**Lane Development -
ATA SITE**

Planning Commission
June 6, 2006

LANE DEVELOPMENT - ATA SITE

Planning Commission Meeting
June 6, 2006

Port Street and Mill Road:

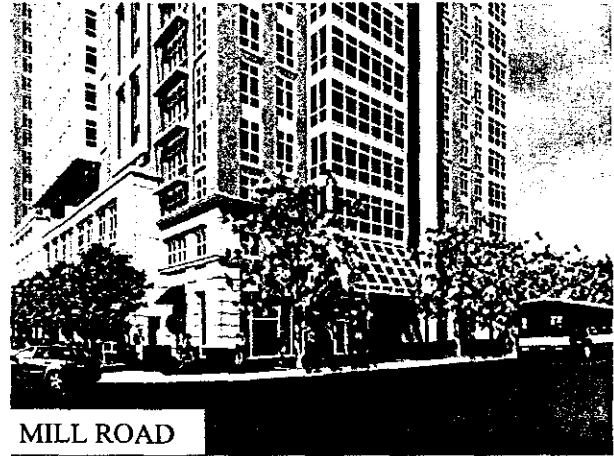
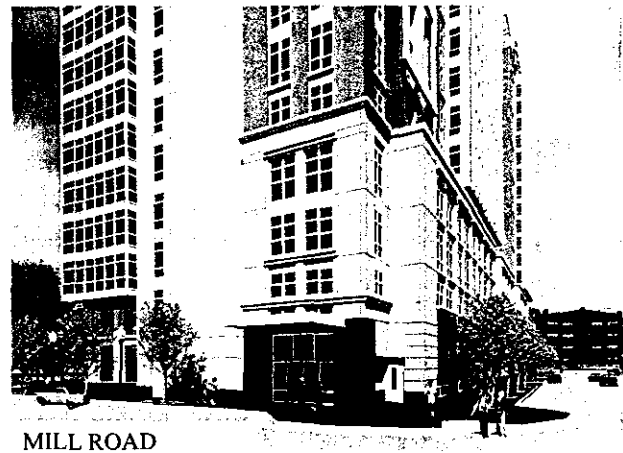
A new street on the western portion of the site, Port Street, is required to be completed prior to the completion of the project and will serve as a primary pedestrian connection from this site to Eisenhower Avenue and the adjoining Metro Station. The primary entrance for the western tower is located on Port Street, and the primary entrance for the eastern tower is located on Mill Road. The entrances on each of these streets will add a significant amount of activity to the surrounding sidewalks.

The sidewalk adjacent to the western pedestrian entrances will be 14 ft wide, and the sidewalk entrance for the eastern pedestrian entrance will be approximately 25 ft. wide. Staff has also recommended that special paving be provided to signify each entrance and that the raised planters be a pedestrian scaled height designed as “seat walls” for pedestrians. While the applicant has proposed that the sidewalks on each of these streets stop at the northern property line, staff is recommending that the sidewalks be extended to Eisenhower Avenue.

Although Port Street will be constructed as part of this proposal, it is unclear when the development of the adjoining Hoffman blocks (Block 11 or Block 12) will occur. Therefore, staff is recommending that the applicant construct a “temporary” asphalt sidewalk and street trees on the western portion of the street until the adjoining block(s) redevelop at which time those temporary sidewalks will be replaced with permanent ones.

- g. The sidewalk on Port Street shall be increased to 14 ft. wide (10 ft. unobstructed) on each side of the street pursuant to the *Eisenhower East Design Guidelines*.
- h. Prior to the issuance of the first certificate of occupancy, the sidewalk on the eastern portion of Port Street shall be constructed. The sidewalk on the east side shall be a 14 ft. wide brick sidewalk with street trees 25 ft. on center. The sidewalk shall extend from Dock Lane to Eisenhower Avenue to provide a continuous 14 ft. wide sidewalk from Dock Lane to Eisenhower Avenue.
- i. Prior to the issuance of the first certificate of occupancy, and consistent with the alignment approved as part of DSUP #2005-0034, a temporary 14 ft. wide

- asphalt sidewalk and street trees from Dock Lane to Eisenhower Avenue shall be installed on the west of Port Street.
- j. The applicant shall maximize on-street parking along Port Street from Dock Lane to Eisenhower Avenue.
 - k. Provide special paving patterns to designate the entrance as outlined in the *Eisenhower East Design Guidelines*.
 - l. The raised planter adjacent to the entrance shall be designed to function as a “seat wall ” for pedestrians. The materials for the planter wall shall be brick and precast stone similar to the materials of the building.
 - m. The proposed exhaust vent shall be relocated to the northern portion of the building within the raised planter.

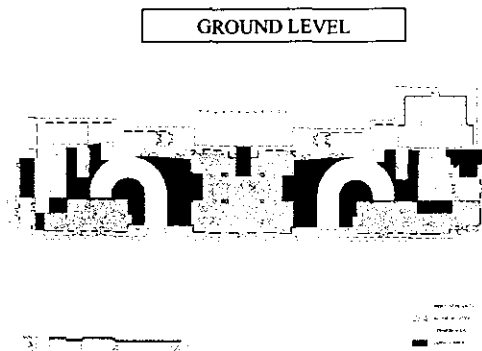
Staff recommends significant changes to the northern edge of the street and the southern face of the building – to both the sidewalk and the building and use configuration – to better accommodate pedestrians. While technically Dock Lane is a “C” street (service street) as defined by the Plan, staff has worked with the applicant to make this environment more appealing for pedestrians.

Although retail is not required by the Plan for this block, the applicant has designed the ground floor to accommodate future retail uses, which could serve the existing building and any future office buildings to the south. Staff has included a recommendation that will require that the loading/unloading areas be consolidated with the proposed garage ramps in order to eliminate the central curb cut and provide more glass and active spaces for retail use along Dock Lane. Staff is also recommending that the garage doors be recessed and that the brick sidewalk material be continued over the curb cut areas. Finally, staff is recommending that additional trees, landscaping and benches be located along the south wall of the building and sidewalk to make the area as attractive as possible.

An additional benefit of relocating the loading/unloading area is the provision of a ground floor space that connects visually from Dock Lane to the open space north of the building. This change will enable more continuous retail-active uses on the street, a stronger retail/pedestrian edge, better lobby space, and a stronger connection to the park open space. With all of these changes, Dock Lane will also be an attractive pedestrian street, helping to create four attractive and varied frontages around the perimeter of the new building.

- p. The applicant shall consolidate the loading/refuse and the retail areas within the existing garage curb cuts to eliminate the central curb cut to provide additional on-street parking and a less interrupted sidewalk for pedestrians and the retail uses.

G. Canopy Encroachment into Port Street

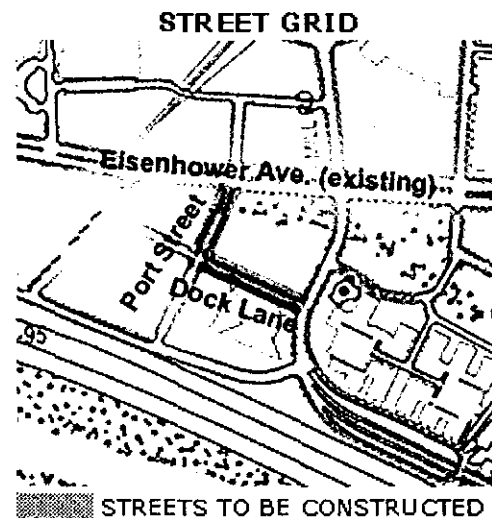
The applicant requests approval of the encroachment of an entrance canopy on the western facade of approximately 8 ft. into the public right-of-way for the proposed building entrance. The entrance canopy is proposed to extend from the face of the building and will extend across a portion of the sidewalk. The purpose of the proposed canopy is to provide shelter from the weather for residents and guests.

Staff supports the proposed encroachment to provide an entrance canopy for the proposed buildings. Canopies of this size and type are typical of buildings of this scale to provide residents and guests with protection from the elements and will be an important amenity for the building. The canopy will be of an appropriate scale to clearly identify the entrance of this urban building. The canopy will not interfere with pedestrian or vehicular movement. While the size of the canopy and the amount of the encroachment may not be appropriate in all instances, this proposal is appropriate as the canopy is needed principally because it is the minimum necessary to adequately serve the needs of a building of this size and scale. For all these reasons staff recommends approval of the canopy as proposed by the applicant.
